**re:     Geotechnical Review of Grading Plan**  
**Proposed Commercial Development**  
801 Eagleson Road – Ottawa, Ontario

**file:   PG2574-MEMO.04**

- ☐ Project No. 148792 – Grading Plan – Sheet Number C-200 – Issue No. 3 dated July 9, 2025.

FIGURE 2 - Paterson Markups for Lightweight Fill  
PG2574-MEMO.04 dated July 29, 2025

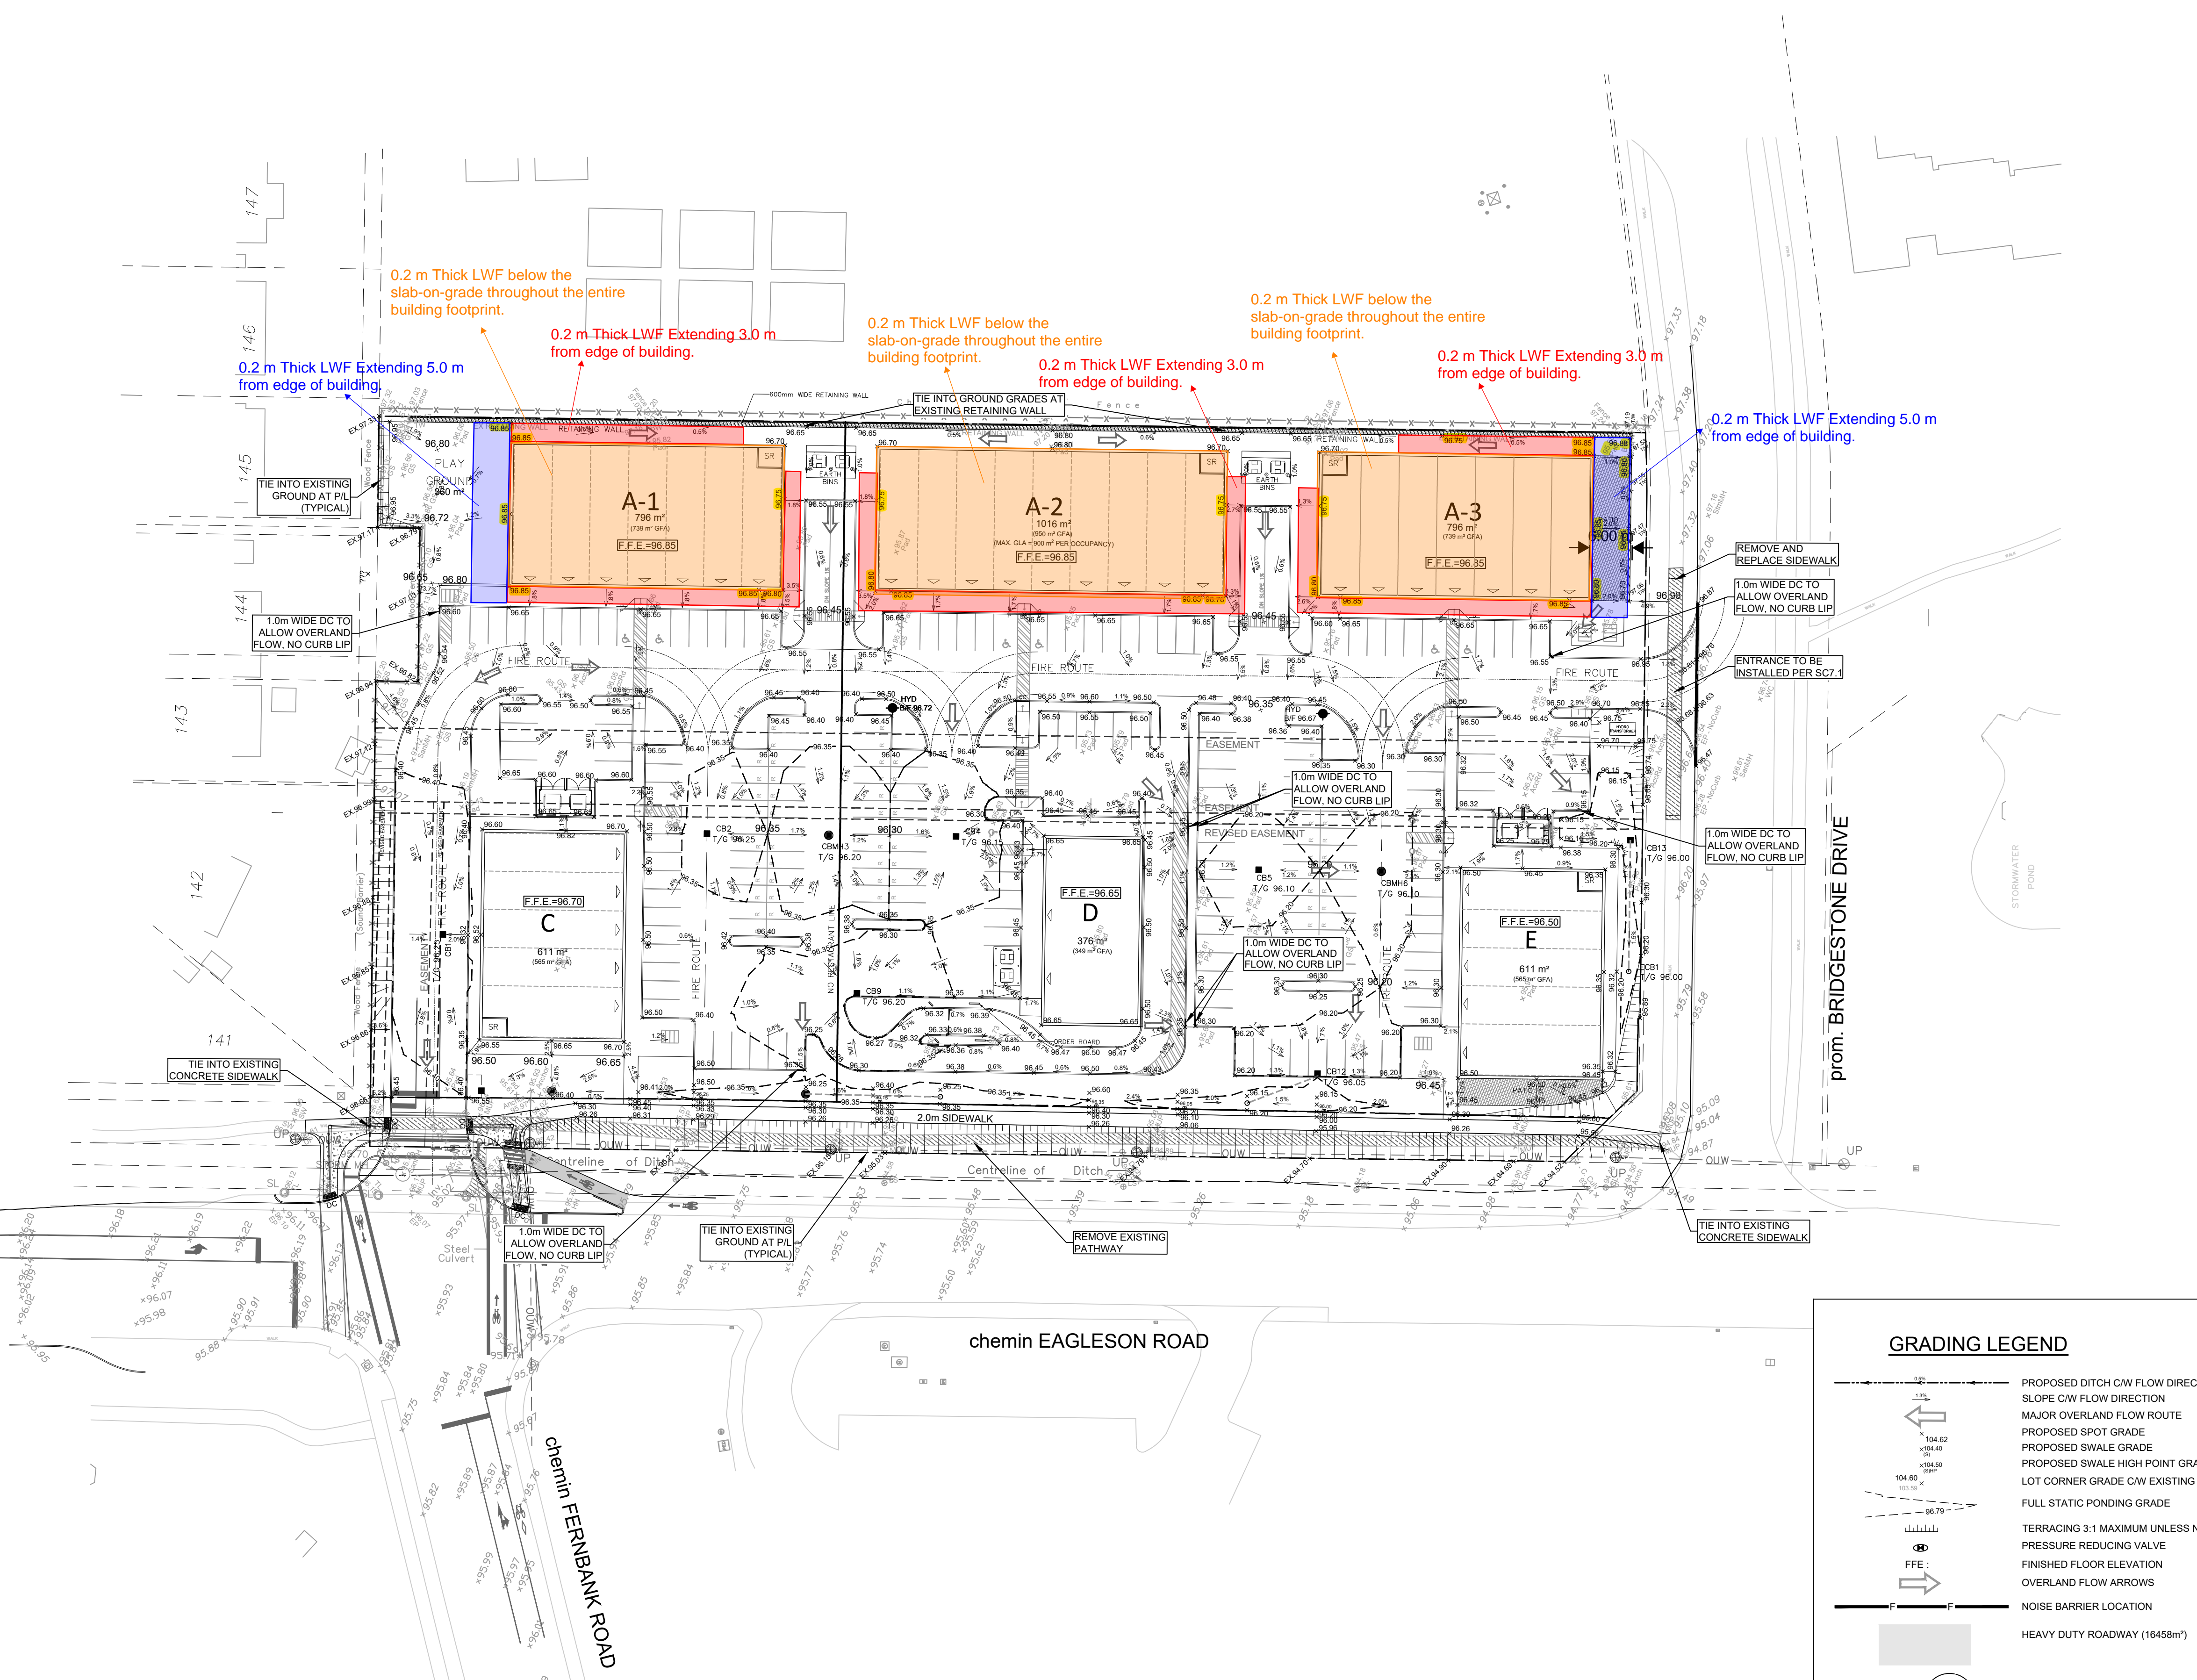
Based on our review, the proposed grading for the subject site is generally within the permissible grade raise recommendations provided in the geotechnical report with the exception of portions of Buildings A-1 to A-3, within the northern half of the property. Where localized grade raise exceedances are proposed, placement of lightweight fill (LWF), such as expanded polystyrene (EPS) geofoam blocks, is recommended below the floor slab and for areas adjacent to the subject commercial buildings. Reference should be made to Figure 2 – Markups for Lightweight Fill Placement, attached to this memorandum, for the recommended thicknesses and extents of LWF for the subject buildings.
